**NOTIFICATION OF ADDENDUM
ADDENDUM NO. TWO
DATED: June 22, 2021**

PR South, Inc. on behalf of Northwest Williamson County Municipal Utility District No. 2

**Parmer Ranch, Phases 2, 3, & 4 Drainage, Paving, Wastewater and Water System
Improvements
City of Georgetown Williamson County, Texas**

Project Number: 22223/01
SCALE: AS NOTED
Project Path: P\22000-22999\22223
Project Name: Parmer Ranch
Drawing Path: Drawings\Plans
Xref DWG FILE:
Sheet Number: 46 of 65 sheets

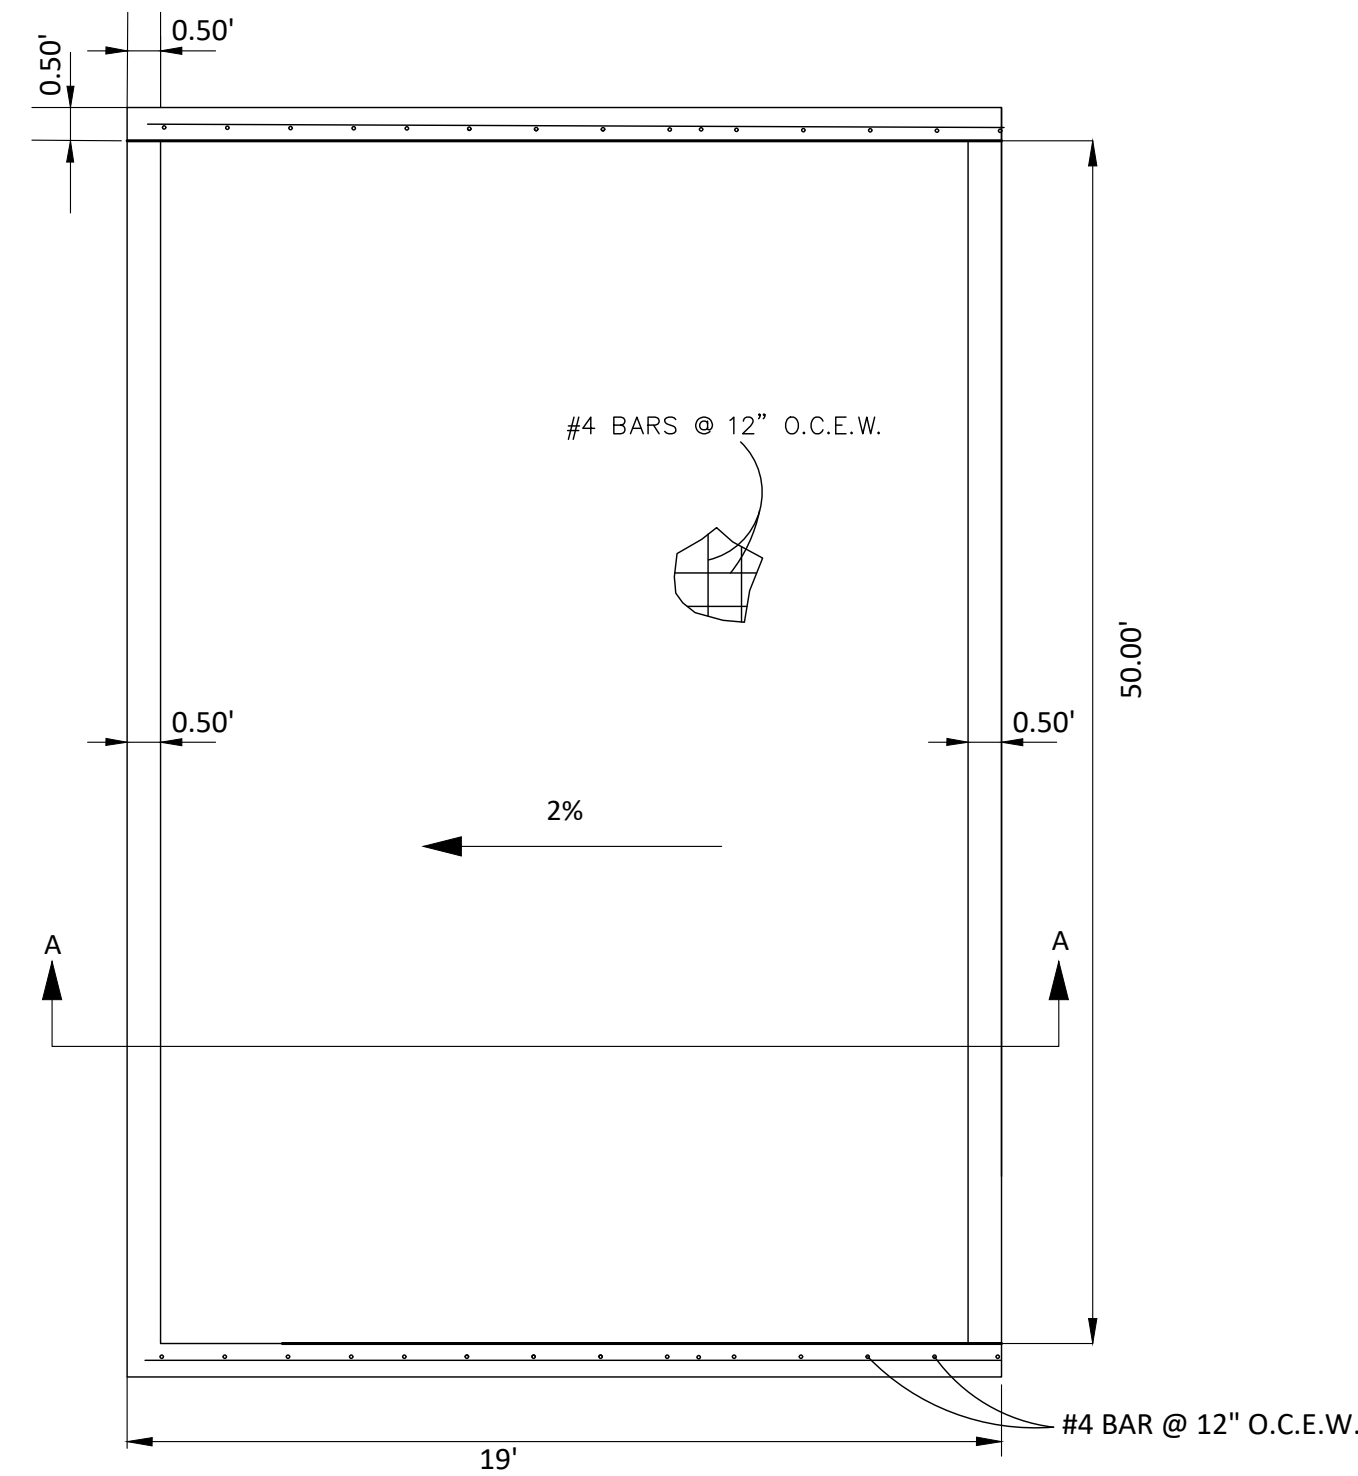
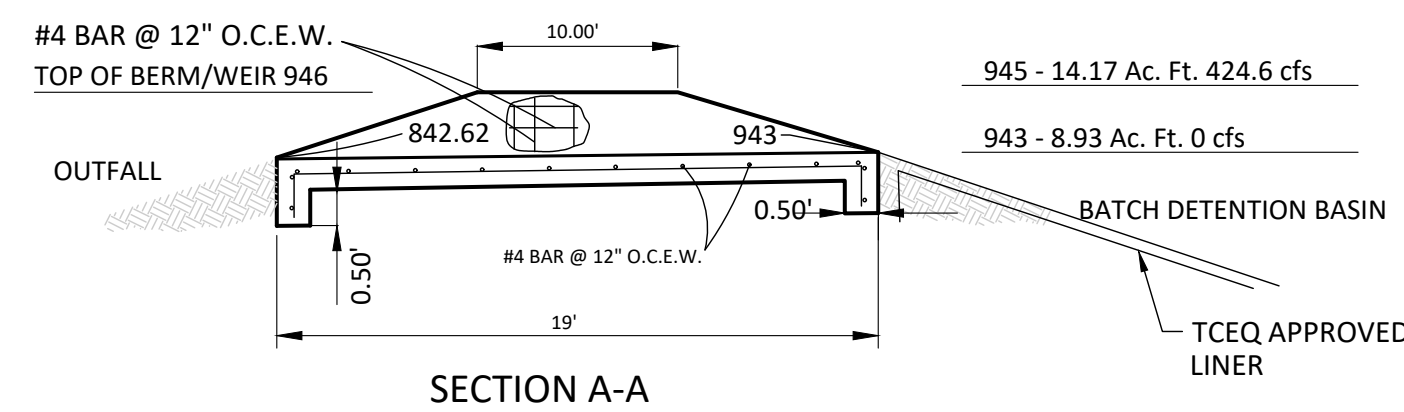
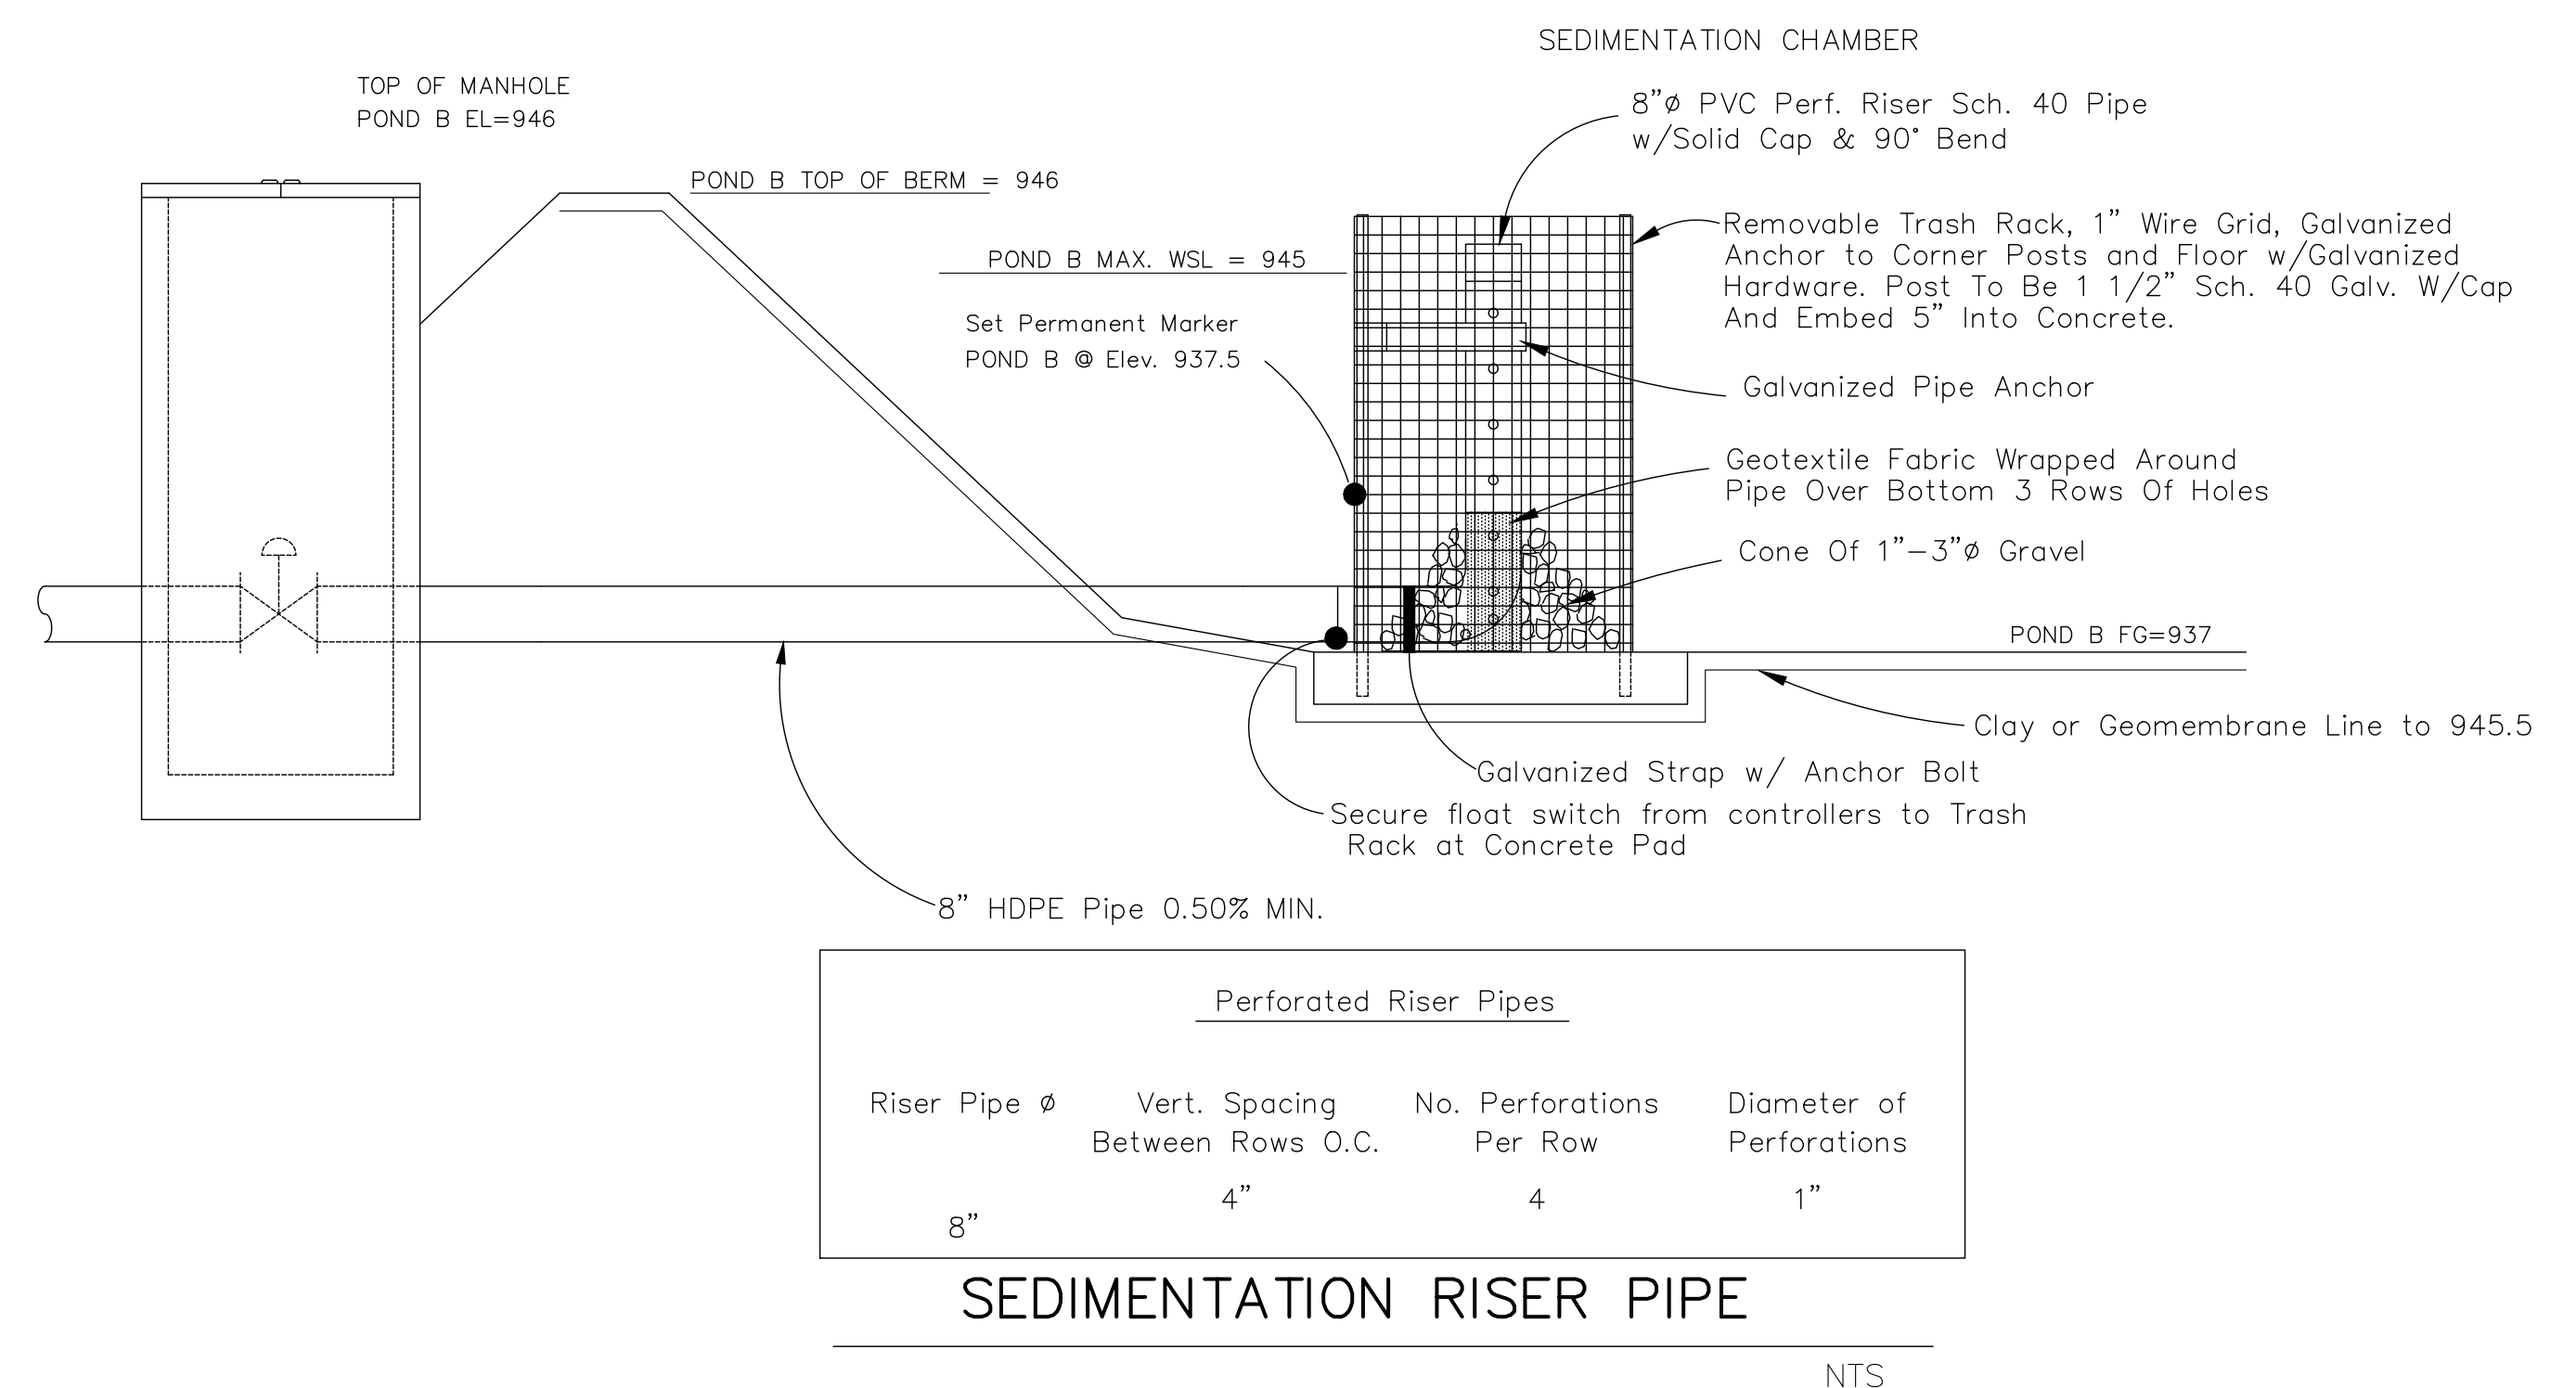
27. Page 45 lists specs for pond liner and then a geomembrane liner. We see no cross section or notes that clarifies if these will be needed and if so to what elevation.
A note calling out the clay or geomembrane liner on the pond section on Sheet 46 has been added with it needed to be installed up to elevation 945.5.

OVERALL WATER PLAN
PARMER RANCH PHASE 2, 3, & 4
 City of Georgetown
 Williamson County, Texas

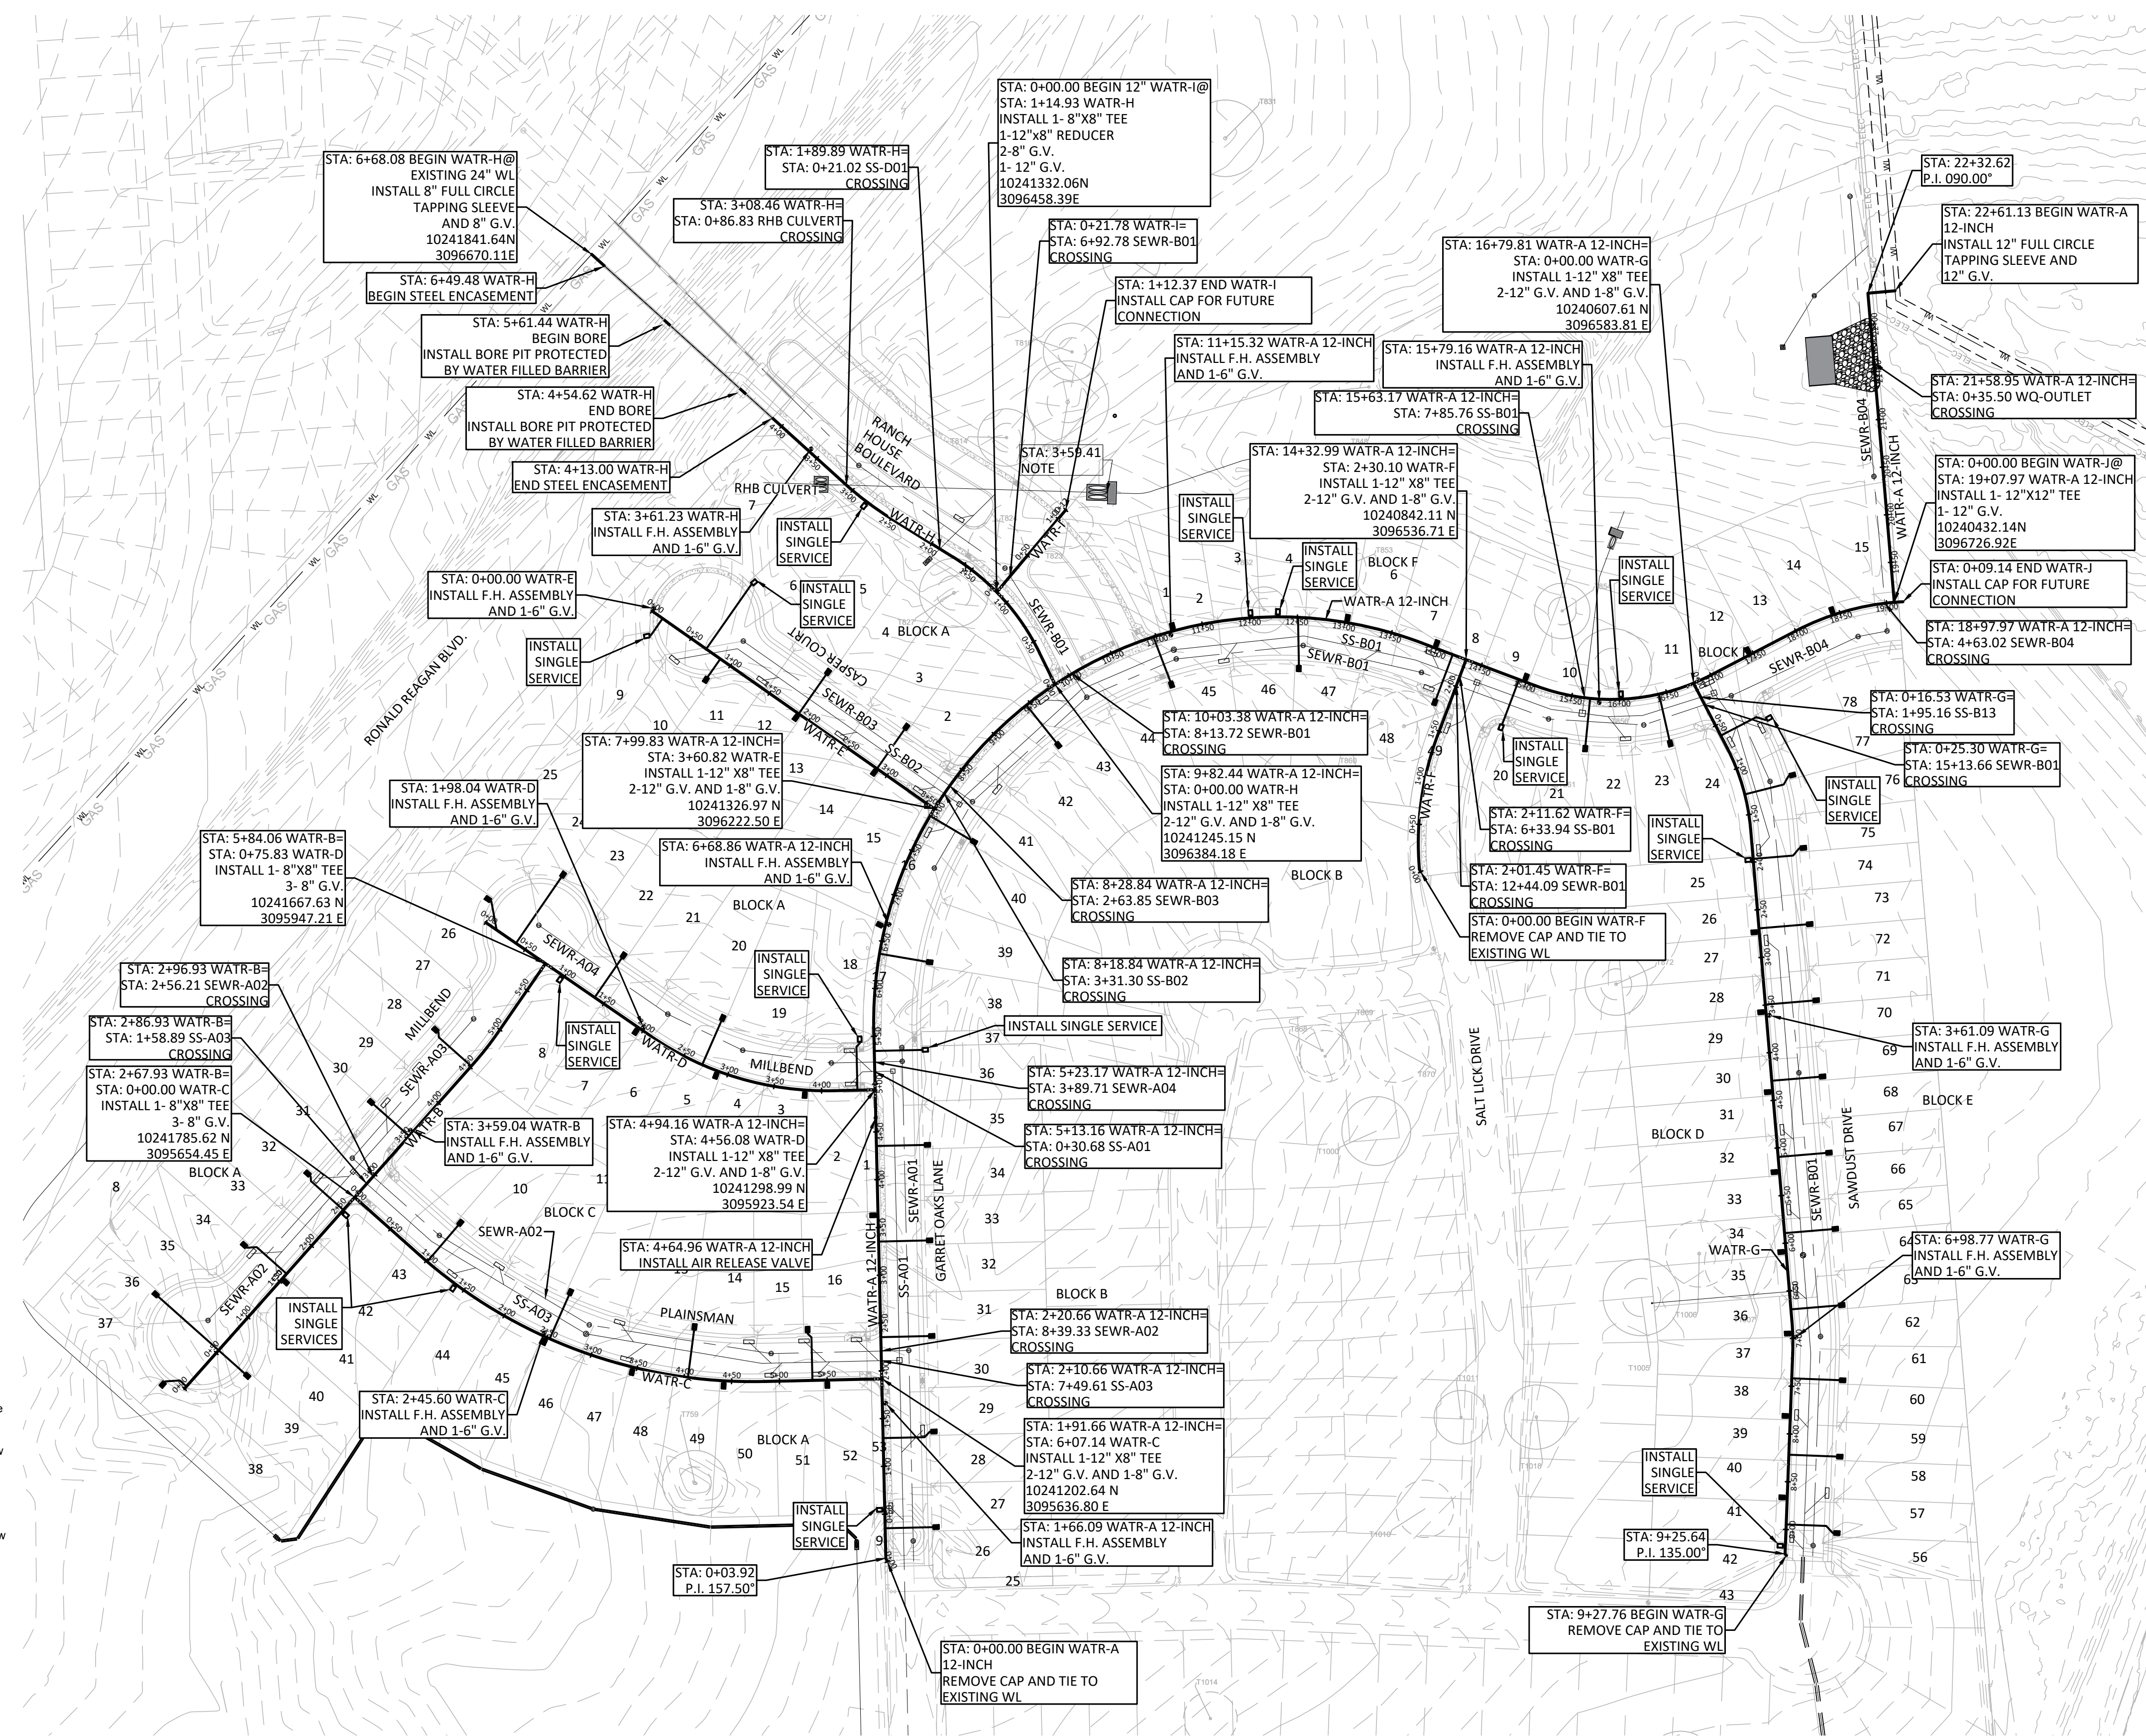
4. Could verify the pipe sizes required for Waterlines H & I? There is a conflicting call out so I just wanted to double check that I am quoting correctly.
Line H is eight-inch and Line I is 12-inch. We have added additional callouts to Sheet 50 included with this Addendum for clarification.

20. There's a possible Gate Valve discrepancy on bid form F6 and F7. Bid form calls for 9 – 8" G.V. and 18 – 12" G.V., however, there were 12 – 8" G.V. and 16 – 12" G.V. called out on the Overall Water Plan (pg 50). Please confirm count.
We count 15 eight-inch and 15 12-inch following the plan updates in response to Addendum Two.
